ACCESSIBILITY PLAN REVIEW

Battery Park Senior Apartments

Re: **ACCESSIBILITY PLAN REVIEW REPORT**
Battery Park Senior Apartments
1 Battle Square
Asheville, North Carolina 28801
NCHFA Project Number TBD
Terracon Project Number F8216301

#6 - Basement Storage: Door

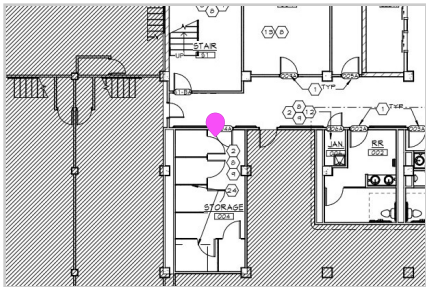
Katie Rich	Issue: There does not appear to be 18" of clearance past the latch on the pull side of the door. Please review.	25 Mar 08:58 AM
------------	---	-----------------

#12 - Trash Chute 13th Floor: Maneuvering Clearance

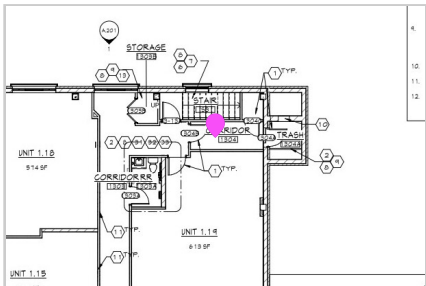
Katie Rich	Issue: There does not appear to be adequate maneuvering clearance to access the trash chute on the 13th Floor (other floors are similar). In addition, there does not appear to be 18" of clearance past the latch on the pull side of the door. Please review.	28 Mar 03:42 PM
------------	---	-----------------

#18 - Mail Area: Maneuvering Clearance

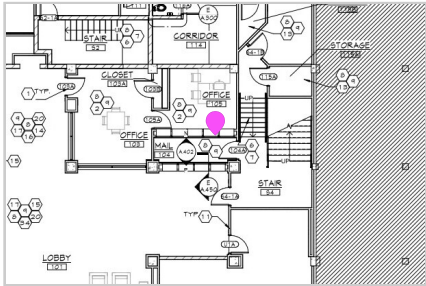
Issue: There does not appear to be adequate maneuvering clearance to access the mail area. In addition, there does not appear to be 18" of clearance past the latch on the pull side of the door. Please review.

Per NCHFA, mail kiosks require 60" minimum clear floor space and with mailbox locks centered on a 48" minimum parallel approach. Mailboxes for all units may not exceed 48" above finish floor.

● #8 - Common Area & Mobility Restrooms: Toilet Paper

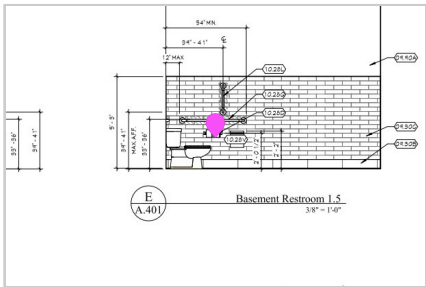
Katie Rich	Issue: The toilet paper dispenser should be located 7" to 9" forward from the lip of the toilet to the center of the dispenser. Please review all restrooms.	25 Mar 10:04 AM
------------	--	-----------------

● #9 - Men's Basement Restroom (003): Urinal

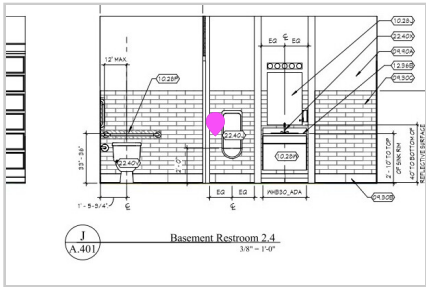
Katie Rich	Issue: Ensure that a minimum of 30" clearance is provided to access the urinal.	29 Mar 03:41 PM
------------	---	-----------------

● #21 - Men's Basement Restroom (003): Door

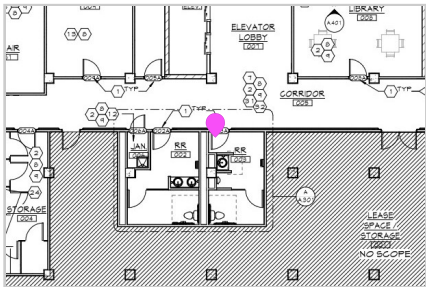
Melissa Middleton	Issue: The required door maneuvering clearance does not appear to be provided on the pull side of the door. A minimum of 48" is required between the door and opposing wall.	05 Apr 01:19 PM
-------------------	--	-----------------

● **#22 - Basement Tenant Storage**

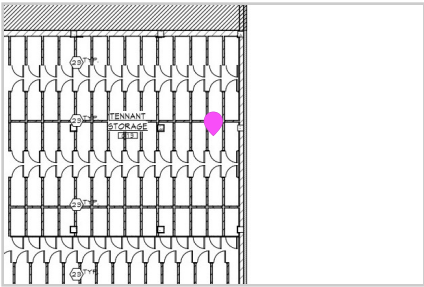
Melissa Middleton	Issue: There does not appear to be adequate maneuvering clearance in the tenant storage area for access.	05 Apr 01:25 PM
-------------------	--	-----------------

● **#23 - 2nd Floor Restrooms: Doors**

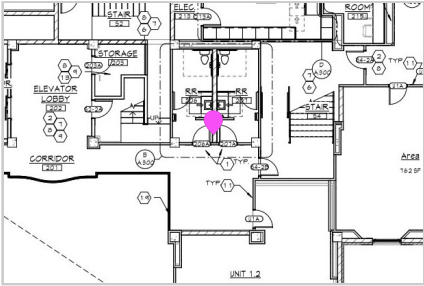
Melissa Middleton	Issue: The required door maneuvering clearance does not appear to be provided on the pull side of the door. A minimum of 48" is required between the door and opposing wall.	05 Apr 02:44 PM
-------------------	--	-----------------

#1 - Mobility Unit: Window Controls

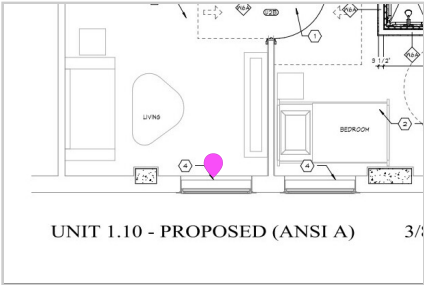
Hamid Dehghan Niri	Issue: Clarify and coordinate the window type. Operable parts should be accessible and within a reach range of 48" above finish floor in all rooms except the kitchen and bath in the designated accessible dwelling units. (No pinching, twisting and turning of the wrist to operate.)	24 Mar 06:19 PM
--------------------	--	-----------------

● #19 - Mobility & Sensory Units: Emergency Pull Cord

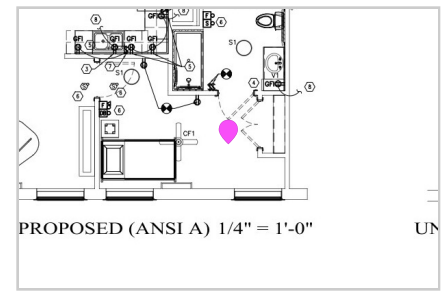
Issue: Emergency pull cords must be mounted no higher than 48 inches from the ground and the cord must be within 6" from the floor.

● #27 - Unit Electrical Panels

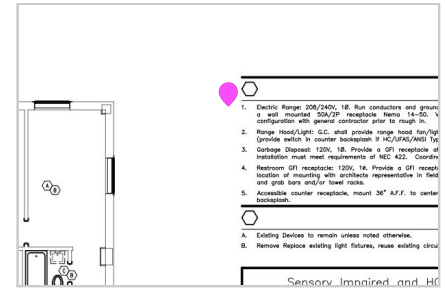
Issue: Per NCHFA, electrical panels in Type A and Type B units must be mounted at 48" maximum above finish floor to top breaker.

● #28 - Mobility Unit: Refrigerator

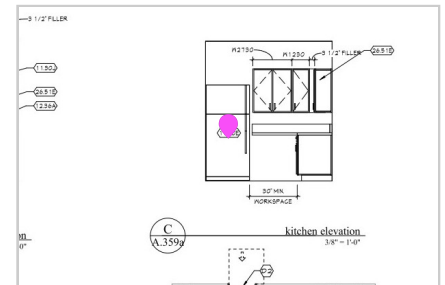
Issue: Per NCHFA, all accessible "Type A" units must have a side by side refrigerator or one with a bottom freezer drawer. The refrigerator doors must be able to open enough for storage bin removal.

● #29 - Mobility Unit: Cabinet Hardware

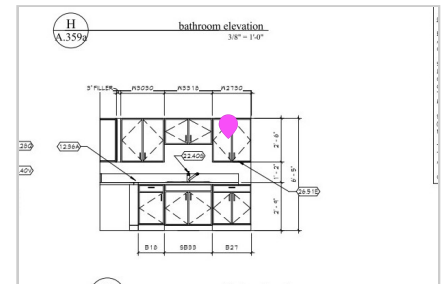
Per NCHFA for elderly properties, loop handles is required on all cabinets and drawers.

● #2 - Unit Mobility: Kitchen workspace

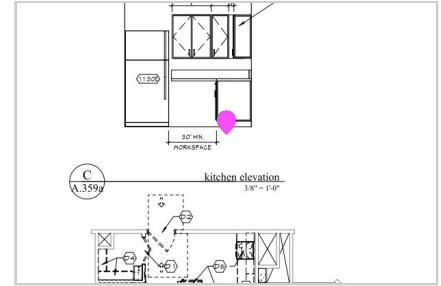
Katie Rich Issue: We recommend that the work surface be located adjacent to the range/oven. 04 Apr 03:07 PM

● #4 - Mobility Unit 1.10: Kitchen Work Surface

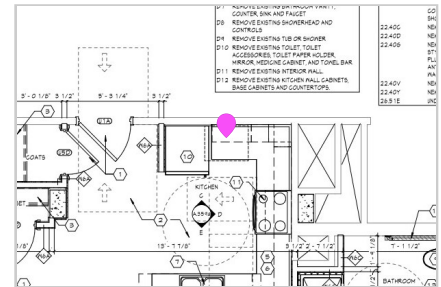
Katie Rich	Issue: We recommend that the work surface be located adjacent to the range/oven. Per NCHFA, the switches for the range hood and light are to be located behind the work station which per the electrical plan is located to the right of the range. Coordinate the work surface area and the switches.	25 Mar 08:48 AM
------------	--	-----------------

● #7 - Mobility Unit 1.10: Range Controls

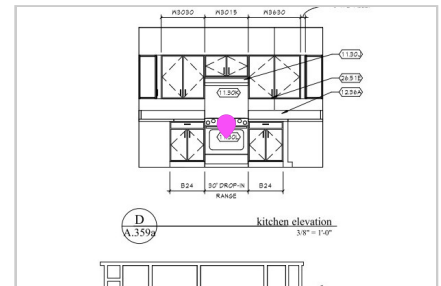
Katie Rich	Issue: Mobility units must have controls located on the front of range. It is recommended that the same range type (11.30C) used in mobility Unit 2.4a is used in Unit 1.10.	25 Mar 09:49 AM
------------	--	-----------------

● #11 - Mobility Unit 1.10: Coat Closet Depth

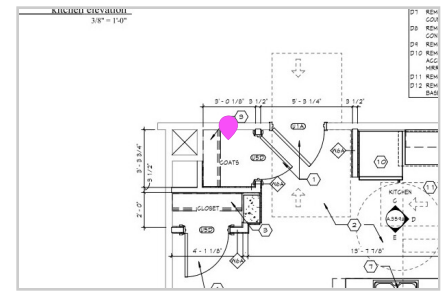
Katie Rich Issue: A maximum depth of 24" from outside face is allowed in the shallow closet if a 32" door clearance is not provided. The closet should be modified. 28 Mar 03:36 PM

● #15 - Mobility Unit 1.10: Door

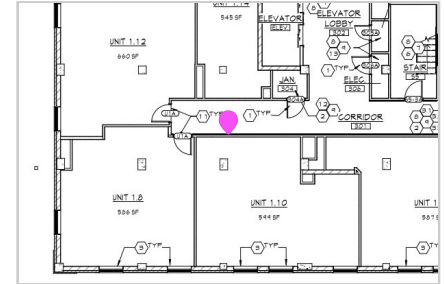
Katie Rich Issue: There is no door provided on the floor plans for this unit. 28 Mar 04:08 PM

● #20 - First Floor Door 109B (Door S1-1B Similar)

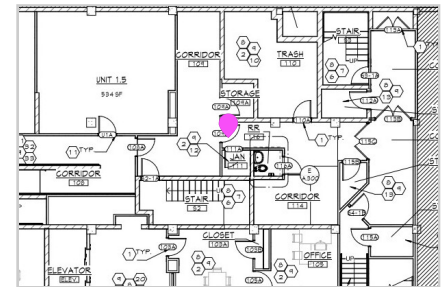
Katie Rich Issue: There does not appear to be 18" past the latch on the pull side of the door. Please review. 30 Mar 02:04 PM

● #24 - Mobility Unit 2.4a: Kitchen Work Surface

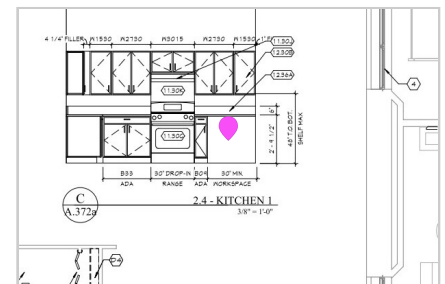
Melissa Middleton Issue: We recommend that the work surface be located directly adjacent to the range/oven. 05 Apr 02:59 PM

Plan: E.309 - ELECTRICAL DWELLING UNIT PLANS | Location: UNIT 2.4

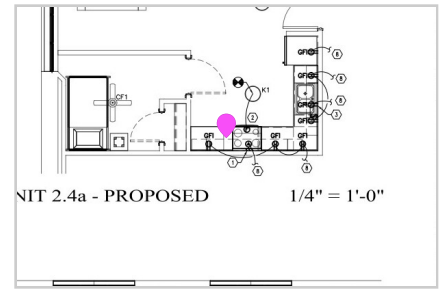
Issue: The hood fan and light controls were not observed in the electrical plans. The controls should be located within the reach range and behind the work surface.
